RE: 143 + 151 East Main Street

I reviewed the new drawings in the context of its immediate neighborhood. My comments and recommendations are as follows:

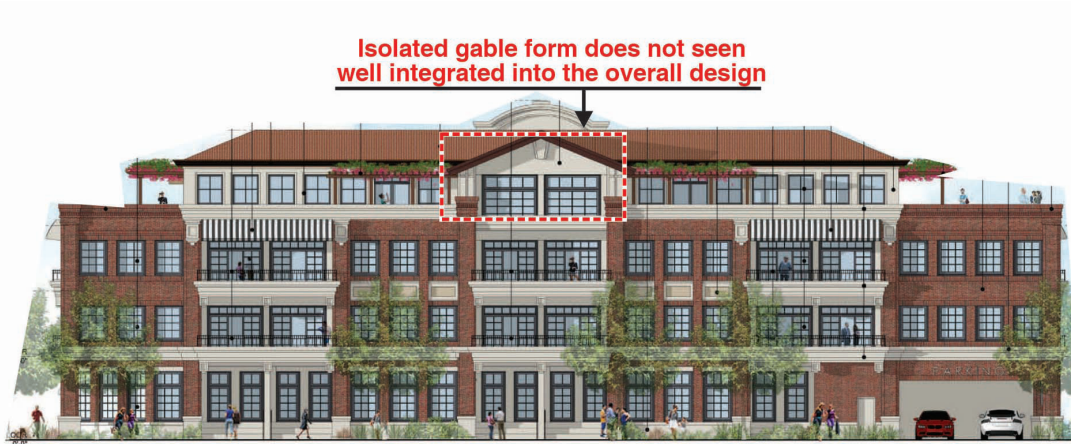
Vertical element seems to over emphasize building height which is greater than other nearby structures

wide concrete area different than on floor plan

Broken up facade treatment appears out of character with the proposed formal architectural style

Both side facades appear very different from front and rear facades

Both side facades appear very different from front and rear facades

2. Extend the stone cornice and decorative stone work consistently around all sides of the building.
3. Add brick spandrel infill on the four story tall wall over the primary East Main Street entry to reduce its vertical emphasis.

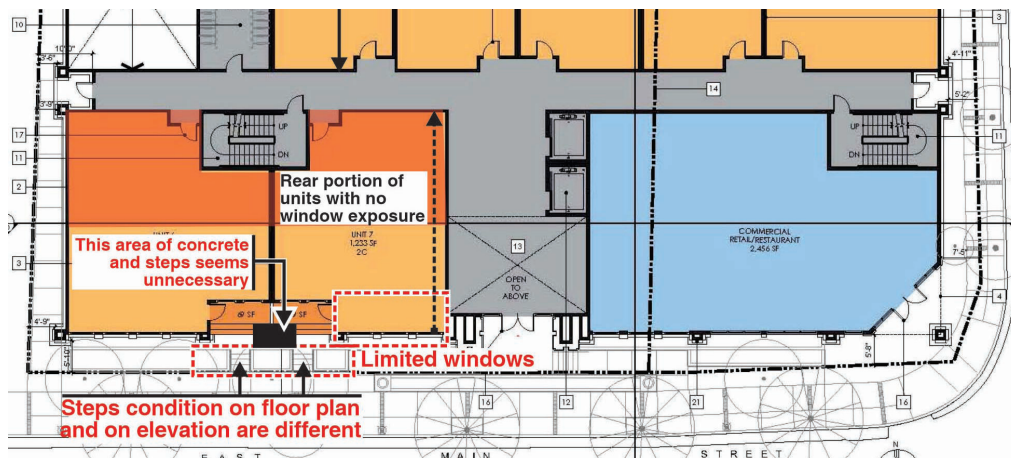
4. The central gable roof on the rear facade is a form not found elsewhere on the building and seems out of place in the overall unity of the design.

5. There is a small issue with the smaller residential unit entries facing the streets. The entries and stairs are shown graphically different on the floor plan and the elevations. The elevation shows a rather long stretch of concrete steps along the East Main Street sidewalk frontage. Given the reduced setback requested by the applicant along the frontage, it seems like an emphasis on more landscaping might be appropriate.
6. One issue of unit livability that might be an issue is the relatively deep units in some locations where some interior living spaces may be further away from a window than normally expected in high quality housing.

4. Modify the gable roof form on the rear facade to blend in better with the overall building design.

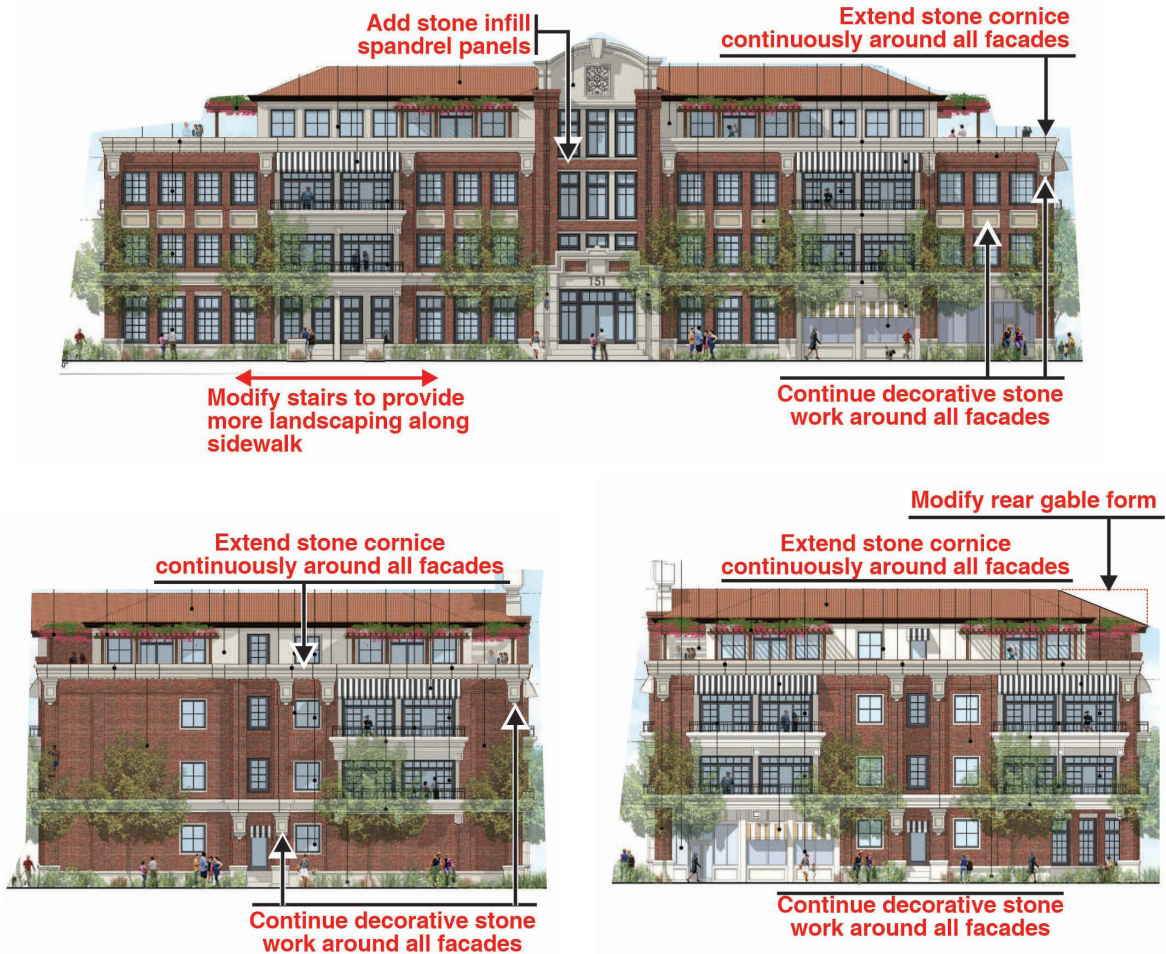
1. Maximize the amount of landscaping along the East Main Street frontage. One example of a similar patio entry along the sidewalk is shown in the photo below.
